Response to Comments

REVISIONS to the KERN COUNTY ZONING ORDINANCE – 2020 (A)
Focused on Oil and Gas Local Permitting

Kern County
Planning and Natural Resources Department
Bakersfield, California

Re: Chapter 7 - Response to Comments for Draft Supplemental Recirculated Environmental Impact Report (2020/2021) – for Revisions to the Kern County Zoning Ordinance – (2020 A), focused on Oil and Gas Local Permitting

Figure 3 – Distribution of orphaned, idle and marginal wells in southern California.

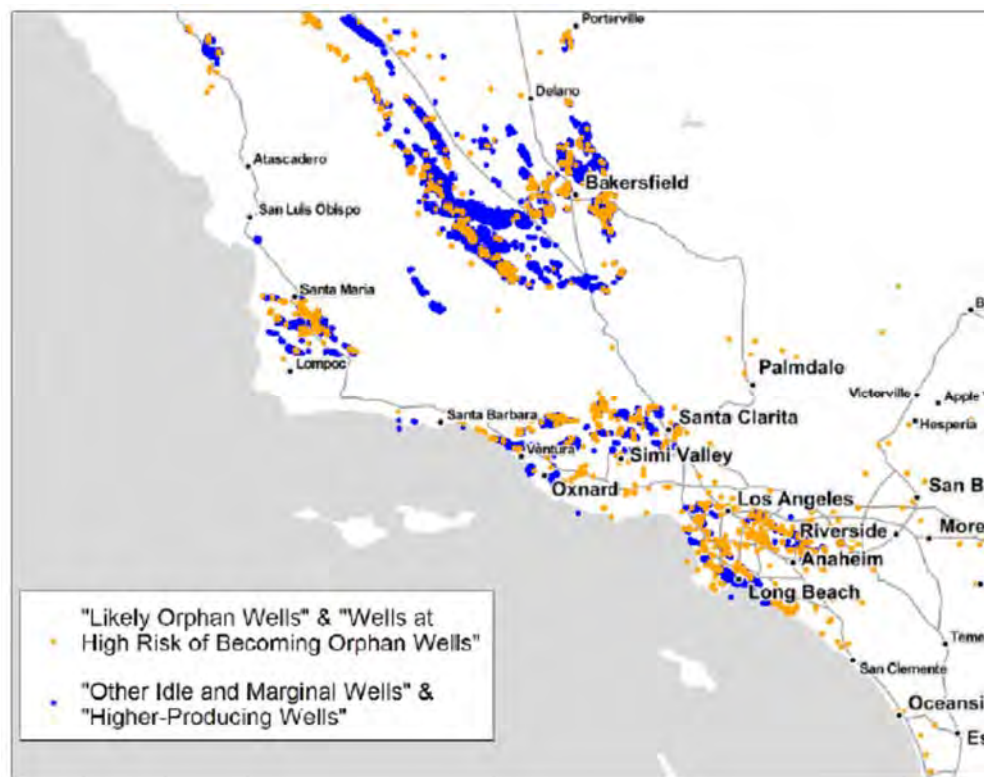
A large proportion of orphaned wells and other idle and marginal wells are in Kern County, as illustrated in Figure 3.

See Comment 0059-44, Table 3 and Figure 3. However, it is not possible to predict the number of future applicants for new wells located on Prime Farmland, Farmland of Statewide Importance, and Unique Farmland that will own or control legacy equipment on the same parcel subject to removal under MM 4.2-1.B. For this reason, the impact of agricultural land conversion, with mitigation, remains significant and unavoidable. See SREIR (October 2020), Vol. 1, at 4.2-40 and Responses to Comments 0059-10 through 0059-12. Creation of a mitigation bank is outside the scope of this SREIR and would be a separate project subject to separate CEQA review. See Response to Comment 0059-12.

Figure C-1: Cost per ton of VERA-funded emission reduction projects 2014–2019

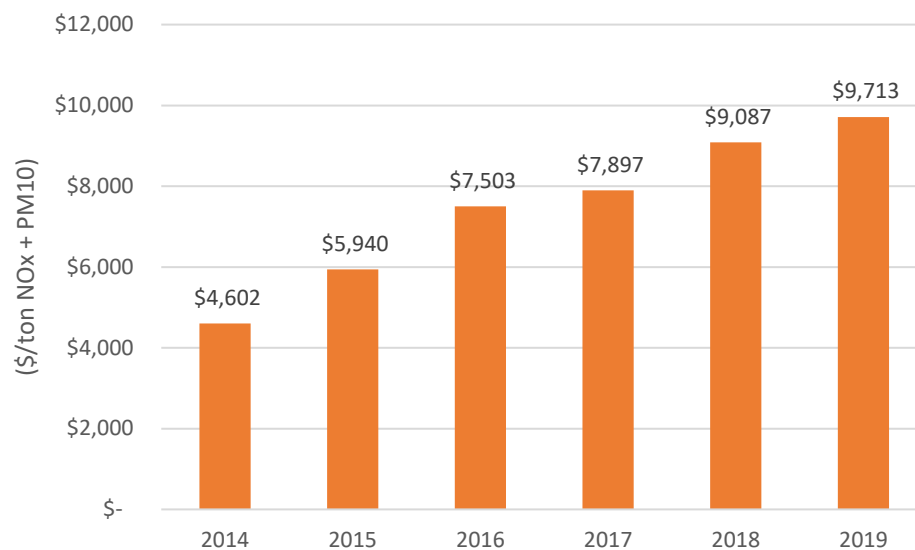
Between 2014 and 2019, the cost per ton of pollutants (NO_x+PM₁₀) removed under the VERA program has more than doubled from \$4,602 per ton to \$9,713 per ton, as shown in Figure C-1.¹ In the same period, the total cost of emissions reductions funded under the ISR program increased from \$9,074 per ton to \$10,988 per ton, an increase of about 20%.² (Total costs under the combined ISR-VERA program increased from \$6,987 per ton to \$10,025 per ton, an increase of about 40%.³)

Figure 5: Size of Cocci Spores Compared to Soil Particles (in mm)

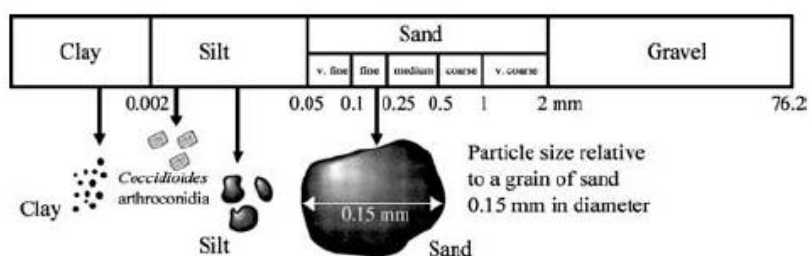
These are “conventional” dust control measures that are not designed to control exposure to Valley Fever spores. It is well known that a conventional dust control plan such as required by these mitigation measures is inadequate to address potential health risks posed by exposure to Valley Fever.⁴⁸ Conventional dust control measures are not effective at controlling Valley Fever⁴⁹ because they largely focus on visible dust or larger dust particles – the PM10 fraction – not the very fine particles where the Valley Fever spores are found. Figure 5. These very small particles are not controlled by conventional construction dust control mitigation measures.
